Access Compliance Report

Public Rights-of-Way

(Curb Ramps)

Intersection ID: 47980	Main Street: WHEAT RIDGE RD	Cross Street: RAFFIA RD	Location: E
ADA ID: 3C961DE62599	Ramp Type: PerpDiag	Initial Pass/Fail: Fail	Overall Compliance: No
Codes/Mitigation Info/Possible Solution		Field Measurements/Component Compliance	
Severity Score: 8.75

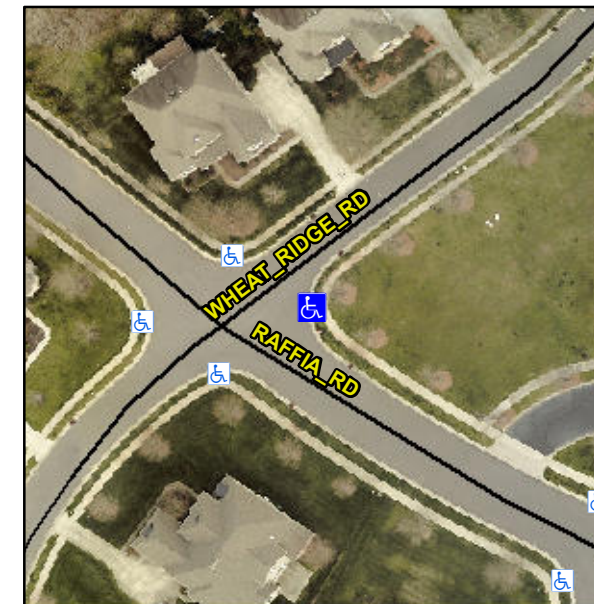
Not Found, R304.5.1

Compliance	Description	Data	Compliance	Description	Data
N/A	Ramp Length (in)	98.0	Yes	Ramp Slope (%)	5.8
No	Ramp Width (in)	47.0	Yes	Ramp XSlope (%)	0.0
N/A	Flare Type LT	N/A	N/A	Flare Type RT	N/A
N/A	Flare Slope LT (%)	N/A	N/A	Flare Slope RT (%)	N/A
N/A	Flare Traversable LT?	N/A	N/A	Flare Traversable RT?	N/A
N/A	Landing Length (in)	N/A	N/A	DWS Provided?	N/A
N/A	Landing Width (in)	N/A	N/A	DWS Contrast?	N/A
N/A	Landing Slope (%)	N/A	N/A	DWS Length (in)	N/A
N/A	Landing X Slope (%)	N/A	N/A	DWS Full Width?	N/A
N/A	Landing Curb? (Y/N)	N/A	N/A	DWS Offset (in)	N/A
N/A	Shared Landing?	N/A			
N/A	Gutter Ponding?	N/A	N/A	Gutter Slope (%)	N/A
N/A	Gutter Lip Ht (in)	N/A	N/A	Gutter X Slope (%)	N/A
N/A	Painted X Walk1?	No	N/A	Painted X Walk2?	No
	X Walk 1 Direction	To NW		X Walk 2 Direction	To SW
N/A	X Walk 1 Width (in)	N/A	N/A	X Walk 2 Width (in)	N/A
	X Walk 1 Slope (%)	0.8		X Walk 2 Slope (%)	0.2
	X Walk 1 X Slope (%)	0.5		X Walk 2 X Slope (%)	0.9

Remove & Replace Curb Ramp With Two New Directional Ramps or Equivalent.
